Minor Amendment of the approved site plan to show future PV carport, location of EV charging stations, and ADA ramps.

The purpose of this letter is to request approval of a Minor Amendment to the previously approved Site Plan-DRB (PR-2021-005390 / SI-2023-00832) at 5000 Central Avenue NE. The Minor Amendment includes minor site plan adjustments to future electrical vehicle (EV) pedestals, the location of a future photovoltaic carport location, and ADA ramp adjustments. The construction has been ongoing for over a year and is nearing completion.

ADMINISTRATIVE AMENDMENT

HILAND PLAZA

A1 SITE PLAN - DRB

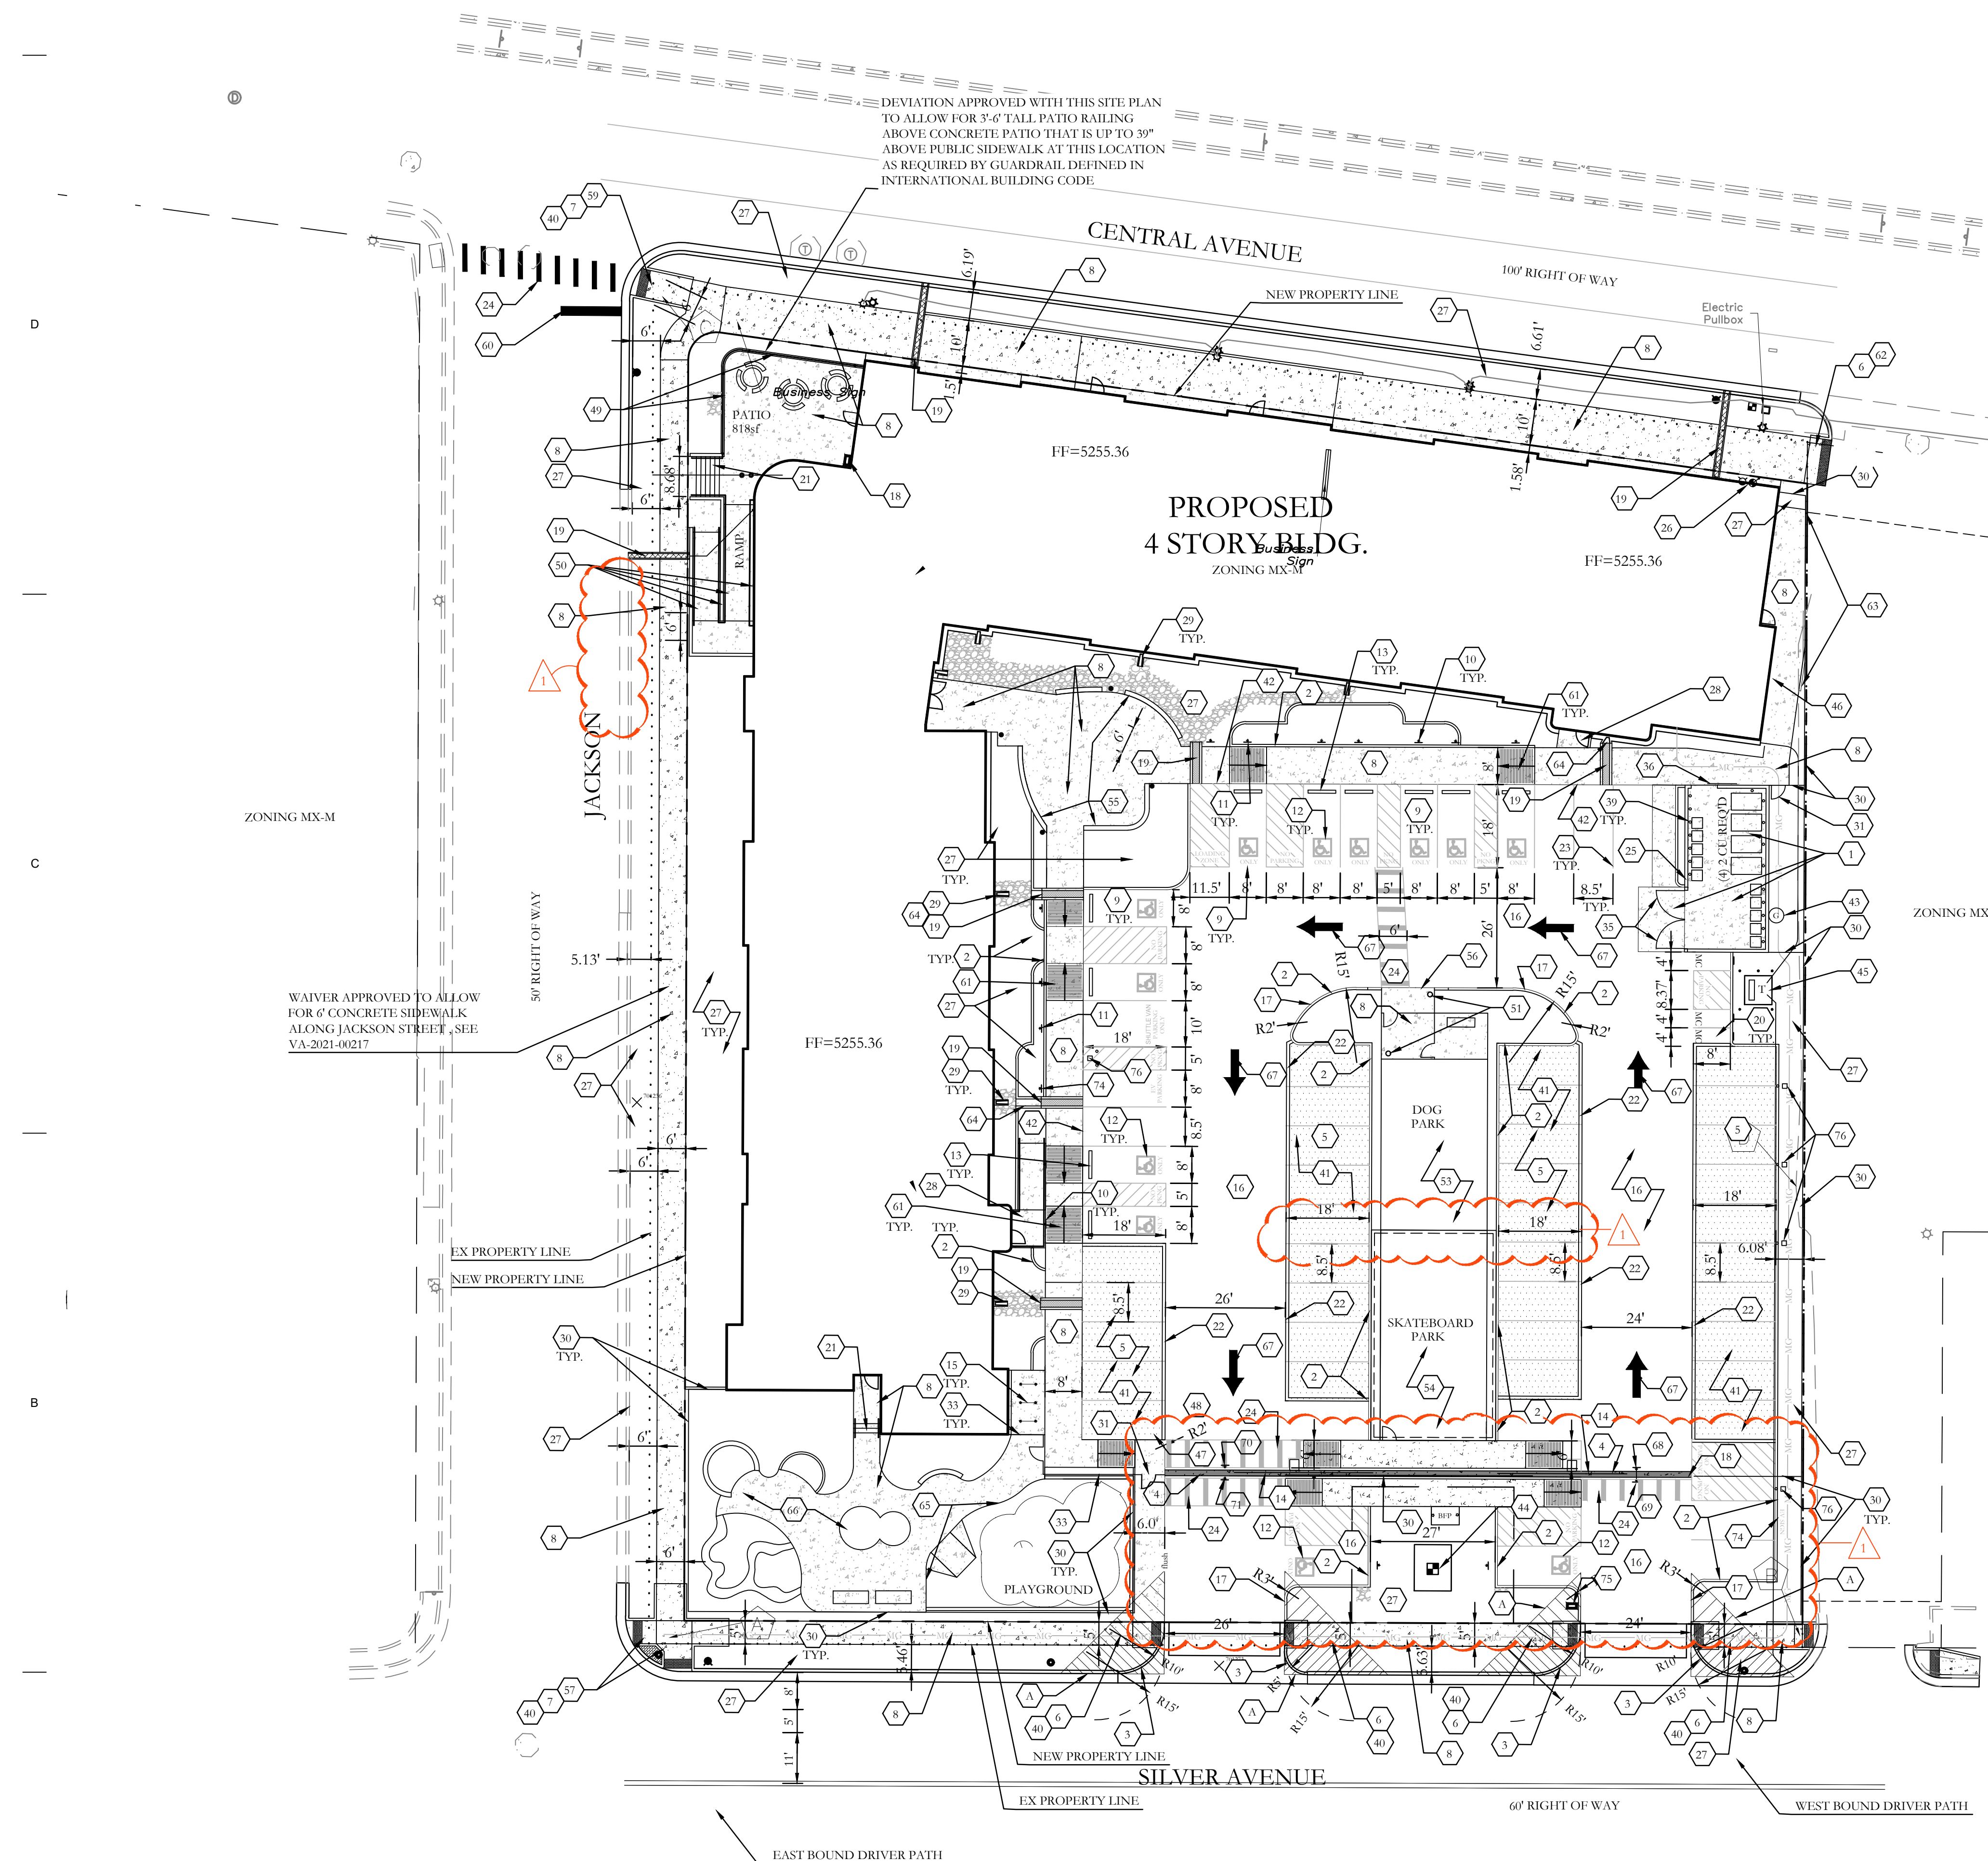
- Addition of future photovoltaic solar carport at the center of the site.
- Addition of two electrical vehicle (EV) parking pedestals on the west side of the site near the ADA parking spaces.
- Relocation of two ADA ramps near the ADA parking spaces on the south side of the site.

FEBRUARY 16, 2023
MINOR AMENDMENT - ON STREET PARKING SPACES
RELOCATED FROM JACKSON ST. TO THE PROPERTY,
ENTRY GATES SHIFTED NORTH TO ACCOMMODATE
RELOCATED ACCESSIBLE PARKING.

LANDSCAPE PLAN

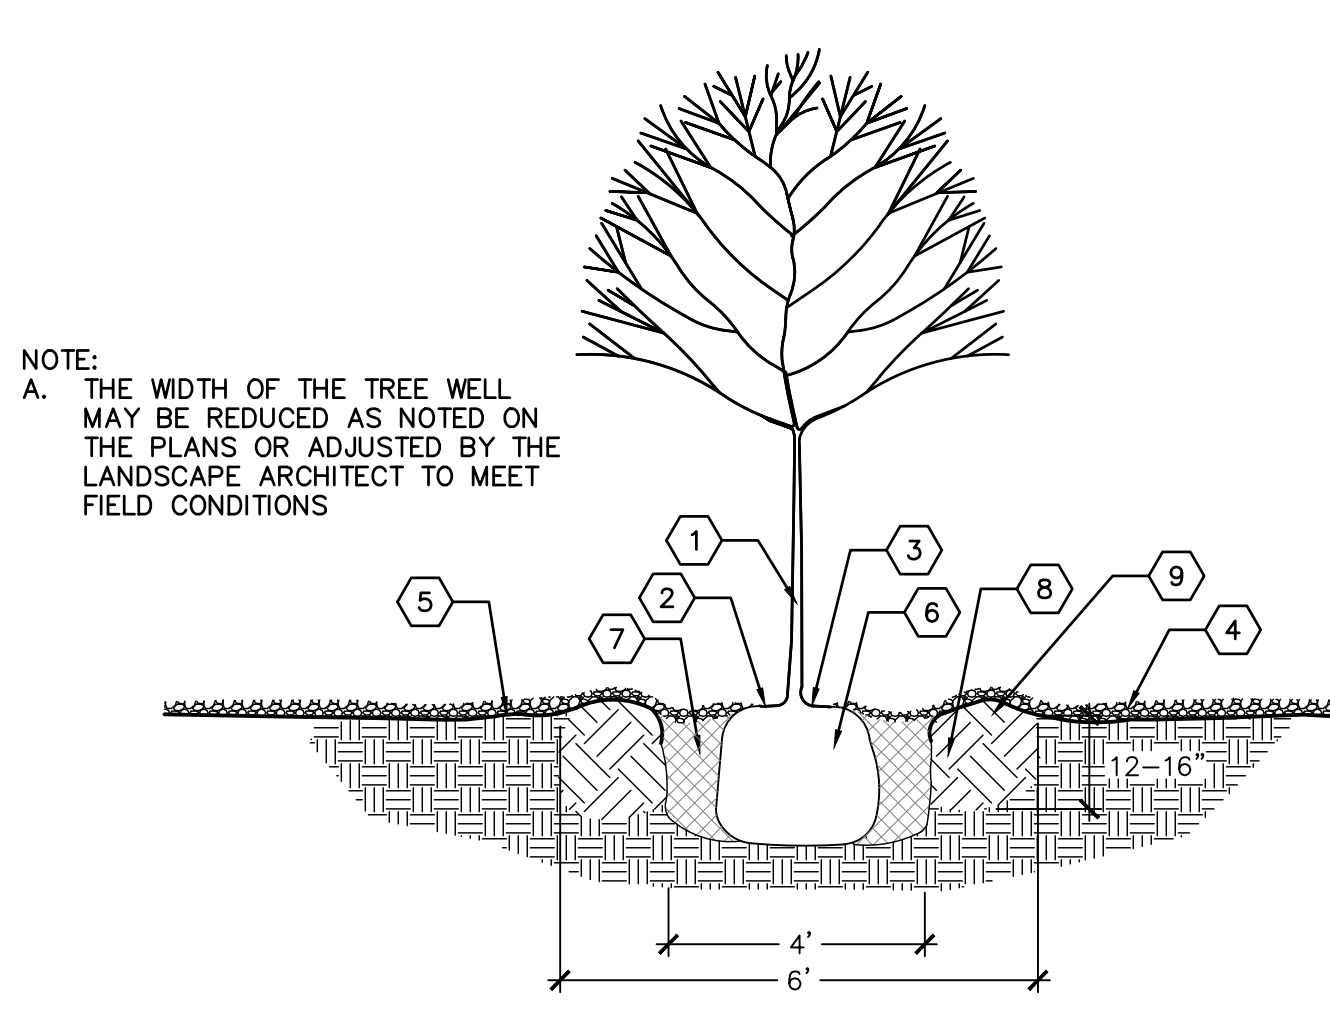
FEBRUARY 16, 2023
MINOR AMENDMENT
LANDSCAPE PLAN CHANGES PER SITE PLAN
